NE-05-84
August 30, 2005

SPECIAL AIRWORTHINESS INFORMATION BULLETIN

2. Subject: Replacement of coolant/Reduction of Cylinder Head Temperature Limits

CHANGE OF COOLANT SPECIFICATION ON ROTAX® ENGINE TYPE 912 AND 914 (SERIES)

4.1) Sticker

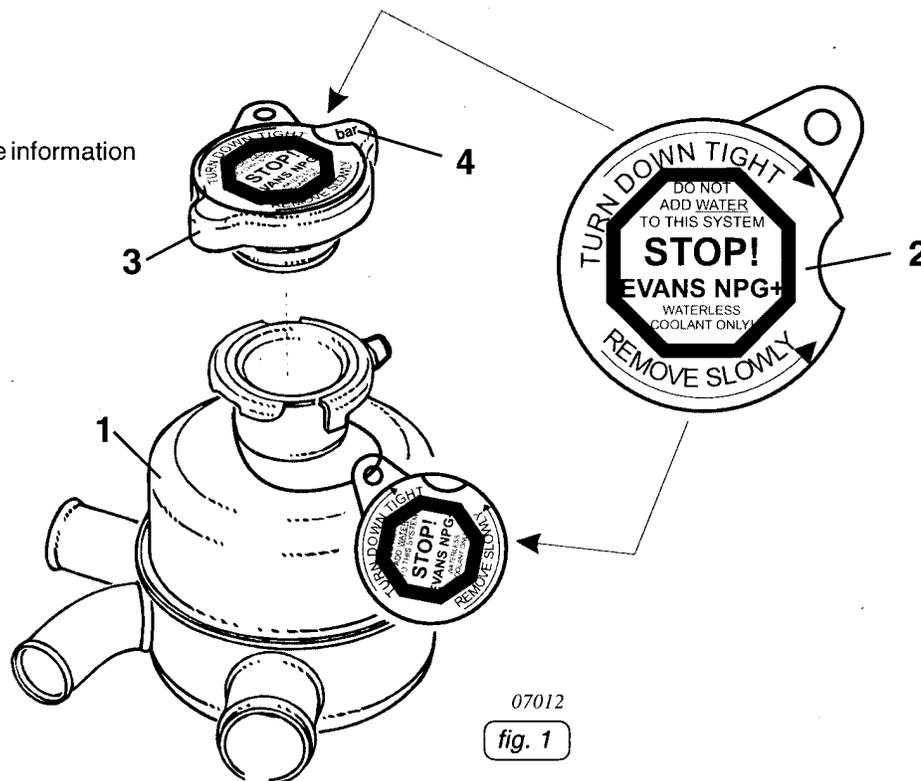
◆ **NOTE:** On the radiator cap (3), to identify the new coolant, the warning label (2) is to be affixed so that the opening pressure data (4) is visible.

- For new engine deliveries the sticker will be temporarily attached to the expansion tank.
- The sticker has to be affixed to the radiator cap in accordance to the aircraft manufacturer's instruction.
